# City of Plymouth Plan Commission

The City of Plymouth Plan Commission will have a meeting on **Thursday August 7, 2025 at 6:00 PM in Room 305**, City Hall, and Plymouth, WI.

The agenda will be as follows:

CERTIFIED SURVEY MAP NO.

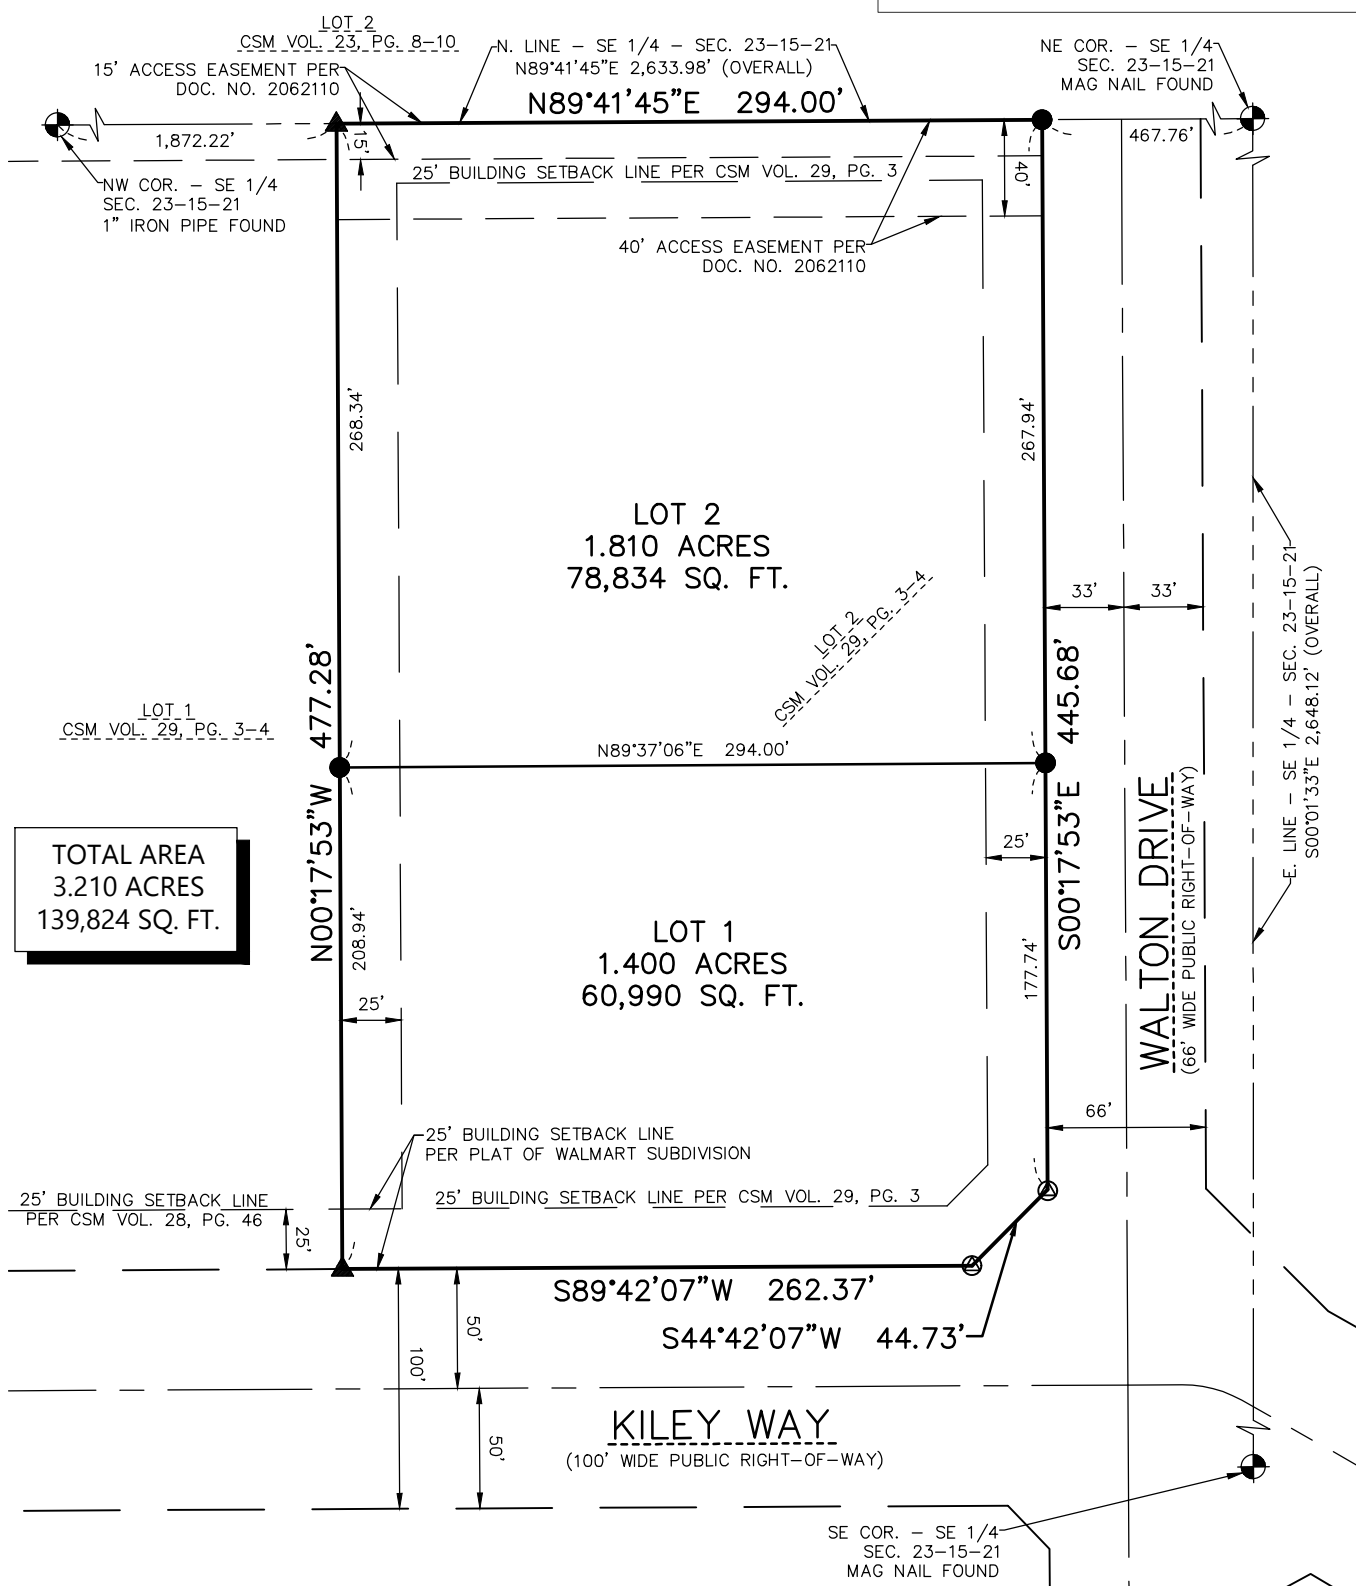
<b><u>Ch./Sec.</u></b>	<b><u>Comment</u></b>
236.34 (1m)(c)	<p><i>The map shall be prepared in accordance with ss. 236.20 (2)(c) Where the exterior boundary lines show bearings or lengths that vary from those recorded in abutting plats or certified surveys there shall be the following note placed along the lines, “recorded as (show recorded bearing or length or both)”.</i></p> <p>Add “recorded as” for any bearings and/or lengths that differ from those shown on CSM Vol. 29, Pg. 3-4.</p> <p>Also, add “recorded as” to the 25’ building setback line noted on Sheet 1, since it varies from the current setbacks for lots that are zoned B-1.</p>
14-1-42 (c) (2)	<p><i>Setbacks or building lines required by the common council and the city Zoning Code.</i> On Sheet 1, list the setbacks according to the appropriate zoning for Lot 1 and Lot 2.</p>
14-1-42 (c) (8)	<p><i>Present zoning for the parcels.</i> On Sheet 1, label the appropriate zoning for Lot 1 and Lot 2.</p>

14-1-42 (e)	<p><i>Certificates. The common council, after a recommendation by the reviewing agencies, shall certify its approval on the face of the map.</i> Add a common council approval certificate to either Sheet 2 or Sheet 3.</p>
